5. CASE 23.003, 88 DEXTER STREET, House, 1825-50 (ARMORY)

Proposal: The scope of work proposed consists of Minor Alterations and includes:

- the installation of seven solar panels to the south slope of the gable-end roof.

Recommendations: The staff recommends the PHDC make the following findings of fact:

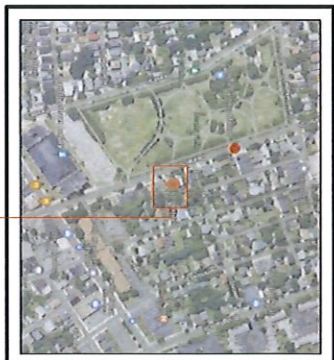
- The modifications as proposed will be visible from the public rights-of-way;
- The property is a lower 1 ½ story residence, with the primary entrance and driveway along the southern boundary. Additionally, the abutting property is a 1 ½ story Cape property, making this elevation prominent from the streetscape. The Commission may consider the south elevation the primary elevation as defined in the Solar Energy System Guidelines. There is a shed dormer set midway on the southern slope. The proposed layout calls for the installation of seven solar panels along the south slope of the gable end roof. This plan identifies four solar panels to be located to the west of the dormer towards Dexter Street, with three panels to the east of the dormer towards the rear of the property. The property also has a rear ell with a gable roof. Staff recommends the application be amended so that as many panels as feasible be placed on the rear ell, with any additional needed panels placed at the rear portion of the south slope of the main roof;

- The modifications as amended meets Minor Alterations: Solar Energy Systems Guidelines, Section 2, in the following manner: Panel layout shall be sympathetic or appropriate to design and scale of building. Rectangular configurations are preferred, with ample setback from edge of roof, dormers, chimneys, etc. (2.A); Panels shall be installed parallel to the existing roof slope and matched as closely as possible to the roof plane (2.B); Panels shall be installed without destroying or replacing original or historic materials or significantly compromising or altering the building's structural integrity (2.C); Panels shall be compatible in color to existing roofing insofar as possible (2.D); Installation of panels shall be as inconspicuous as possible when viewed from public right-of-way (2.E); Installation shall be reversible. Panels shall be removed when no longer viable or functioning and roofing restored to pre-existing conditions (2.F); and,

- c) The work as amended is in accord with PHDC Standards 8 & 9 as follows: 8) the work will be done so that it does not destroy the historic character of the property or the district as they are not on the primary elevation and will be minimally-to-not visible from the public rights-of-way; and, 9) Whenever possible... alterations to structures shall be done in such a manner that if removed in the future, the essential form and integrity of the structure and the site will be unimpaired.
